City of Melville

DEVELOPMENT ADVISORY UNIT MEETING

Matters for consideration	Notes from meeting
UP26/141	DA-2026-642 - Additions and Alterations to Grouped Dwelling – Lot 2 (No. 2) Haig Road, Attadale

- This development application seeks approval for alterations and additions to a grouped dwelling at Lot 2 (No. 2) Haig Road, Attadale (the subject site).

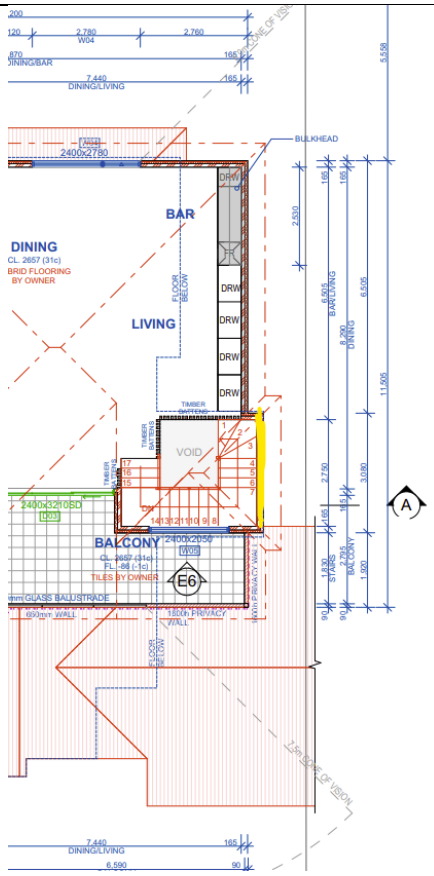
Concerns were raised by the submitters in relation to the upper floor rear (south) and western side lot boundary setback non-compliances proposed. As noted above, the rear (south) and side (west) lot boundary setbacks do not meet the deemed to comply provisions of the R-Codes and requires a design principles assessment. The proposed development is considered to meet the relevant design principles as discussed below:

Design Principles	Assessment:
P3.1: *Buildings set back from lot boundaries or adjacent buildings on the same lot so as to:* • *reduce impacts of building bulk on adjoining properties;*	**Southern Wall – Upper Floor** The setback of the wall ranges from 5.7m to 7.2m with the bulk of the wall being setback further than 6m, See Figure 2 below. Given the bulk of the wall is setback more than 6m, the wall bulk impact to the adjoining property is negligible and is a better outcome than a deemed to comply wall setback at 6m.  **Figure 2: Upper Floor rear 6m minimum rear setback non-compliance with the rear (southern boundary) being top of image** **Western Wall – Upper Floor** The proposed setback of 1.1m is only 0.1m less than the deemed to comply requirement and therefore the discretion sought can be considered minor in nature (See Figure 3 below). Furthermore, the proposed wall which has setback of 1.1m is limited to 3m in length, substantially less than the permitted 9m length, thereby reducing the extent of building bulk experienced from the adjoining western property and maintaining an appropriate separation between the two properties.

**Figure 3: Upper Floor plan showing Stairwell location (marked in yellow) with western boundary being to right of image**
• *provide adequate sunlight and ventilation to the building and open spaces on the site and adjoining properties; and*	**Southern Wall – Upper Floor** Notwithstanding the discretion sought to the rear setback, the proposed setback of 5.7m to 7.1m provides adequate separation between the development and adjoining property. This separation ensures that access to sunlight and ventilation is maintained for buildings and open spaces on both the subject site and adjoining properties, with no undue impact on residential amenity. **Western Wall – Upper Floor** The discretion sought and when considered in conjunction with the limited length of the wall, is not expected to materially restrict access to sunlight or ventilation. The proposal therefore maintains adequate sunlight and ventilation to buildings and open spaces on both the subject site and adjoining property, while limiting the extent of building bulk presented to the adjoining property.
